Service Bulletin

No. : MZ07-021

Model: SR4001, SR5001

Subject: Correction of the Service Manual, System Error Information.

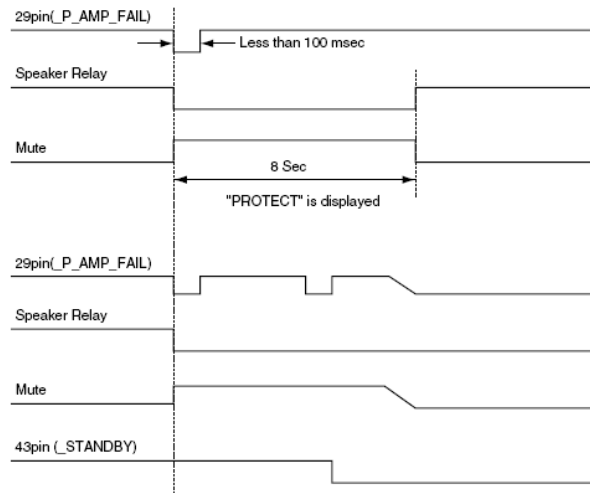
2. When "L" of less than 100msec is detected by 29pin (Power Amp Fail) of IC17, Speaker Relay becomes OFF and MUTE becomes ON state, and the state is held for 8 seconds. At this time, "PROTECT" is displayed. When similar abnormal detection was considered to be it for these 8 seconds, the unit will be in standby mode and STANDBY LED will blink. When it was not detected abnormally for 8 seconds, the unit returns to normal use state.

CHECKPOINT

1. Check AMP PWB.
2. When AMP does not have a problem, it is confirmed whether there is not abnormality by disconnection of pattern of 29pin (Power Amp Fail) and the detect circuit.
